**Proposed FY 2025 Electric
Infrastructure, Safety, and
Reliability Plan**

**Responses to Division Data
Requests Sets 2 through 6**

Docket No. 23-48-EL

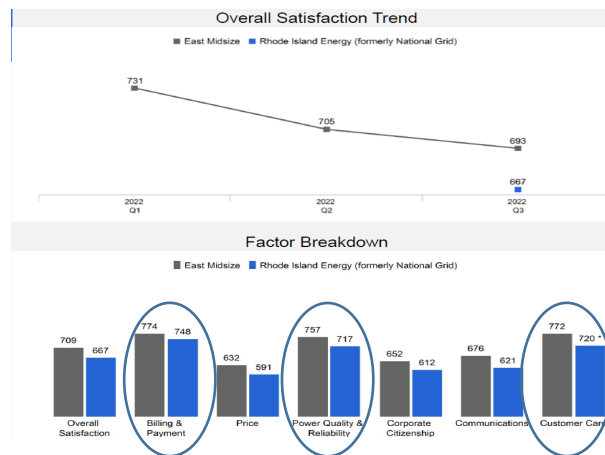
Confirm that the JD Power Satisfaction Study examines six factors: Power Quality and Reliability, Price, Billing and Payment, Communications, Corporate Citizenship, and Customer Contact. Provide Rhode Island Energy's results for each factor and for overall satisfaction compared to other midsize eastern utilities, to the extent available, for each quarter of 2023, 2022 and 2021.

The J.D. Power's Residential Customer Satisfaction Study examines the following six factors: Power Quality and Reliability, Price, Billing and Payments, Communications, Corporate Citizenship, and Customer Care.

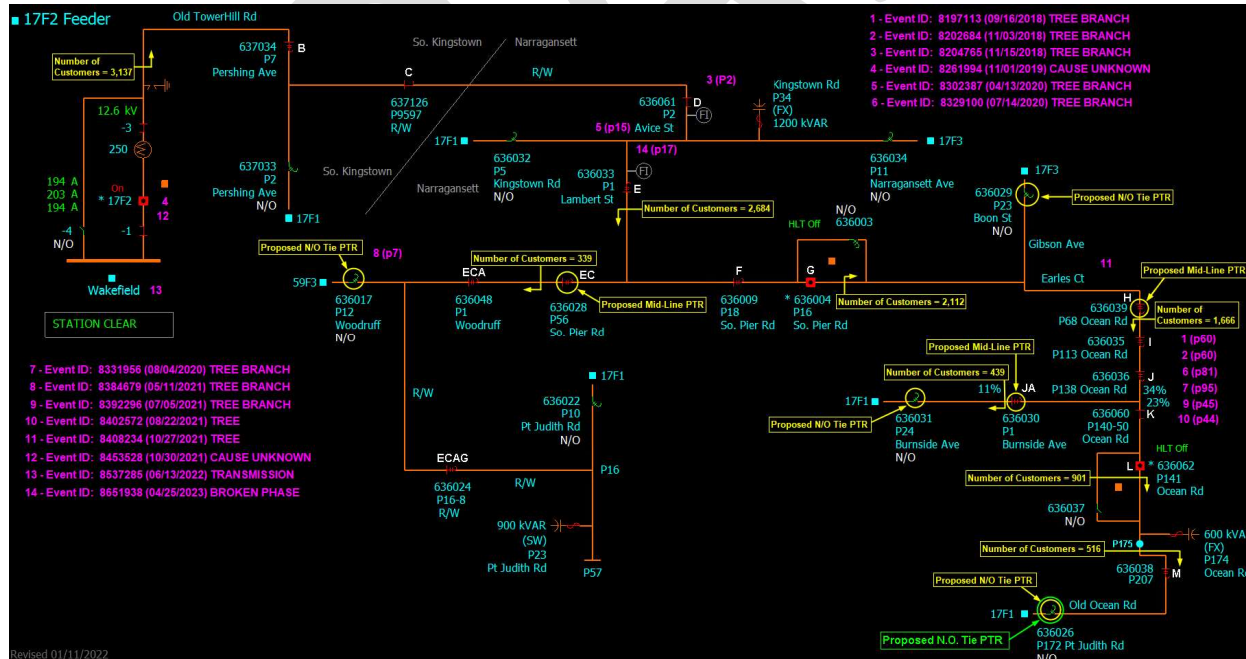
Provide a list of each circuit proposed for work under the worst performing circuit program in FY 2024. For each circuit, provide information comparable to pp. 155-159.

Attachment DIV 4-13 contains the reports for the FY 2024 worst performing circuits.

Figure 1. RIE historic SAIFI performance

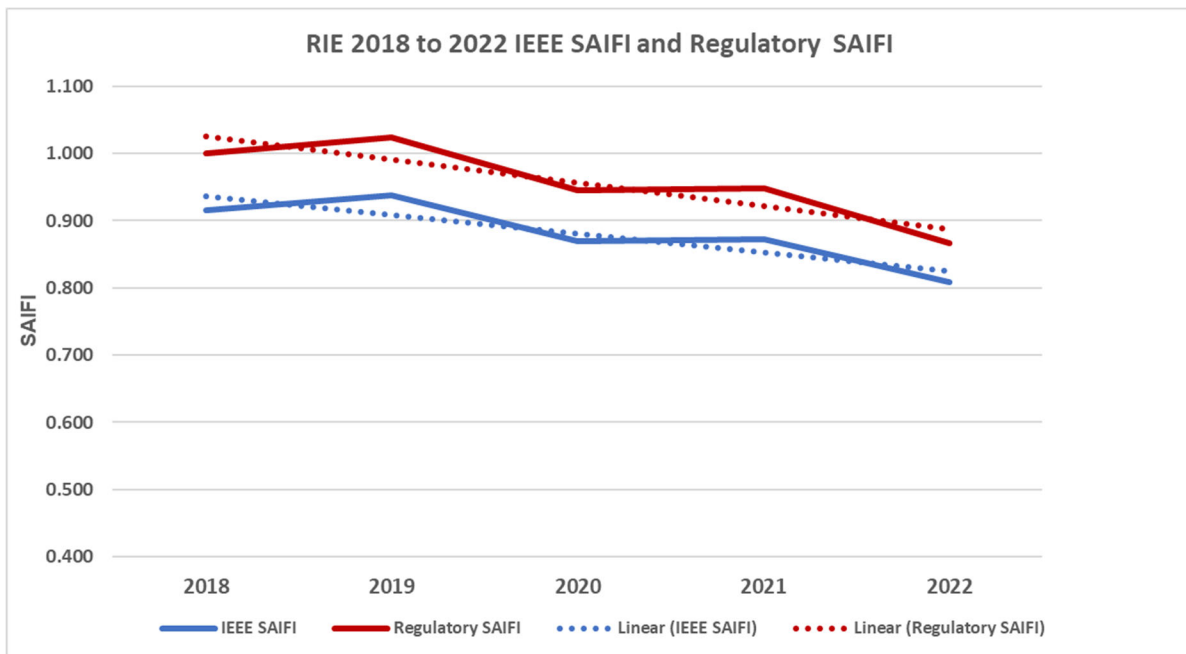
Provide the RIE historic SAIFI and SAIDI performance with trend lines (Figures 1 and 2, pp 124) for the past five years. Is RIE's system performance declining, steady, or improving over that time?

Figure 1 and Figure 2 are RIE historic SAIFI and SAIDI performance in the past five years. Both SAIFI and SAIDI are showing improvement over this period.
